Project	IEEE 802.16 Broadband Wireless Access Working Group < http://ieee802.org/16 >	
Title	Problems with DBPC Messages and a Solution	
Date Submitted	2005-03-13	
Source(s)	David A Castelow, Gavin Meakes, Eyal Verbin Airspan Communications, Cambridge House, Oxford Road, Uxbridge, UK	Voice: +44 1895 467281 Fax: +44 1895 467202 mailto:dcastelow@airspan.com
	Chi-Chen Lee, Tzu-Ming Lin, Yu-Ren Yang, Chia-Feng Kang CCL, ITRI, Bldg. 11, 195 Sec. 4, Chung Hsing Rd. Chutung, HsinChu, Taiwan 310, R.O.C.	mailto:jjlee@itri.org.tw
	Rainer Ullmann, Donald Stevenson Wavesat Inc, 1375 Trans-Canada Highway Suite 300 Dorval, Quebec H9P 2W8, Canada	mailto:rullmann@wavesat.com
Re:	Document to support comment to Letter Ballot #17	
Abstract	Changes required to prevent DBPC message flooding of 802.16 systems	
Purpose	The document is intended for consideration in comment resolution process of LB #17.	
Notice	This document has been prepared to assist IEEE 802.16. It is offered as a basis for discussion and is not binding on the contributing individual(s) or organization(s). The material in this document is subject to change in form and content after further study. The contributor(s) reserve(s) the right

Figure 1

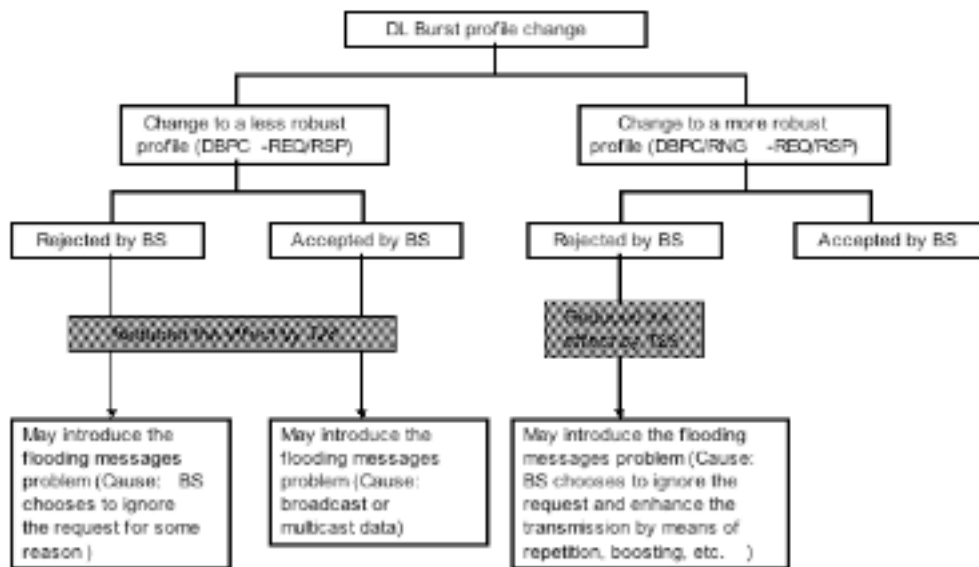
Figure 1 summarizes the scenarios of the flooding problem, and the suggested remedies (T28/T29).

Figure 79—Transition to a more robust operational burst profile

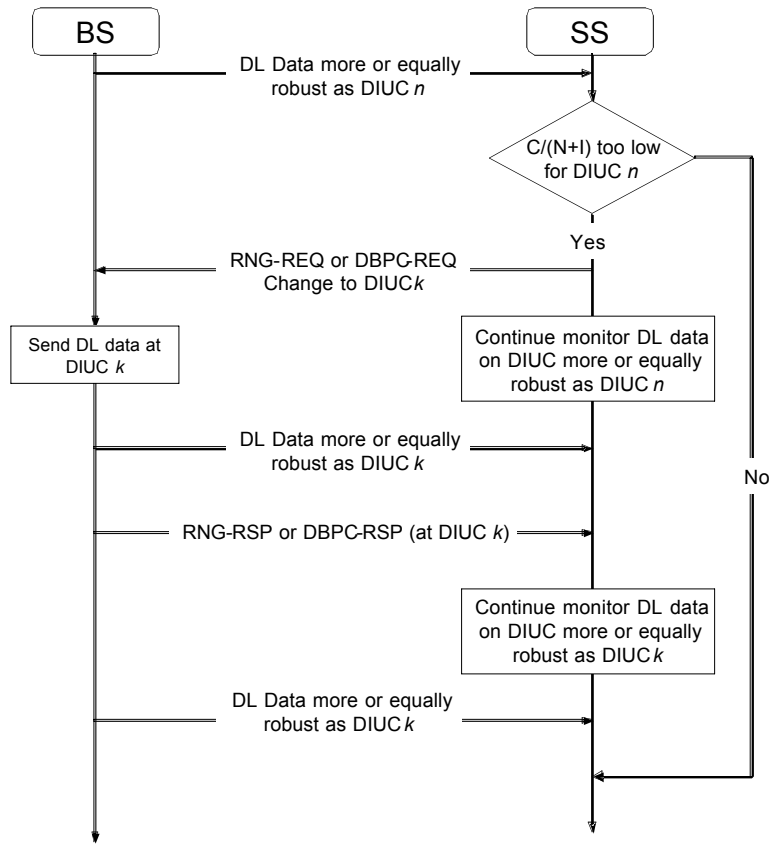
Page 200: Figure 79 needs to indicate action of SS in event of non-detection of DBPC-RSP.

Also DL data may be on DIUC up to m, not at m. This requires a change to Figure 79, too.

Change Figure 79 as indicated:

Figure 80—Transition to a less robust operational burst profile

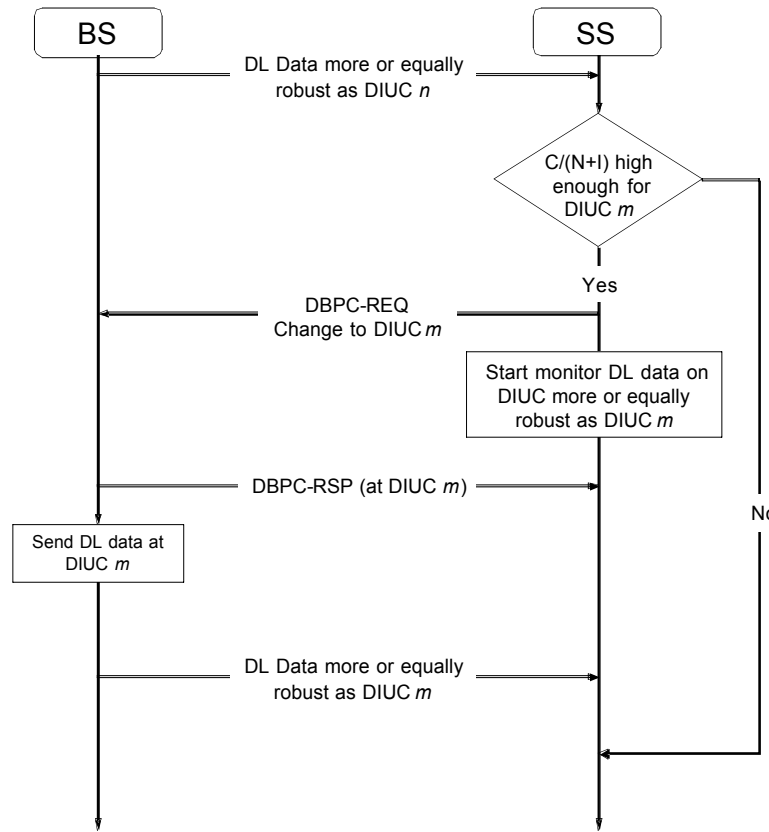
Page 201: Figure 80 needs to indicate action of SS in the event of the BS refusing the DBPC-REQ to move to a less robust modulation. State transition diagrams are needed here, so rather than complicate these diagrams, we introduce a separate figure. This diagram requires timers, so that the BS is not flooded with requests. The diagram (Figure 80a) indicates the actions for the SS, and includes new timers (T28, T29, and T30).

RNG-REQ only to be used for transition to more robust cases when no grant is available (see 6.3.10.1).

This requires a change to Figure 80. This leads to the following text changes in [4]:

Change Figure 80 as indicated:

Figure 80a – State transition diagram for downlink burst profile management – SS

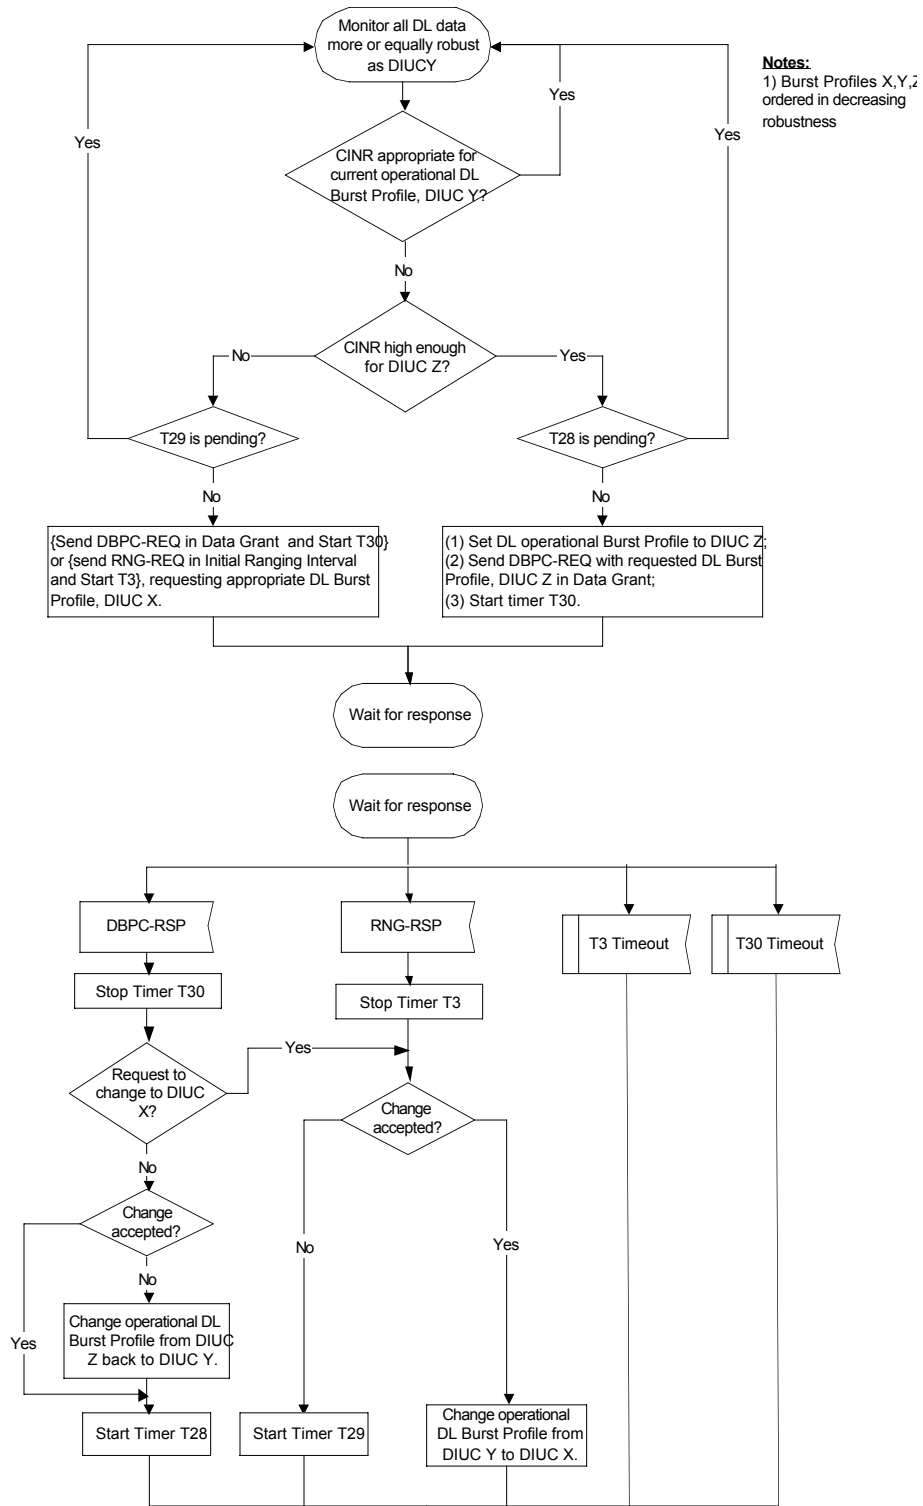
Insert new Figure 80a (see end of contribution).

System	Name	Time reference	Minimum value	Default value	Maximum value
SS	T28	DBPC-REQ re-try timer for requesting less robust burst profile.	200 ms	1 s	1 min
SS	T29	RNG-REQ/DBPC-REQ re-try timer for requesting more robust burst profile after rejecting by the BS.	200 ms	1s	30s
SS	T30	DBPC-RSP reception timeout following the transmission of a DBPC-REQ.	200 ms	200 ms	200 ms
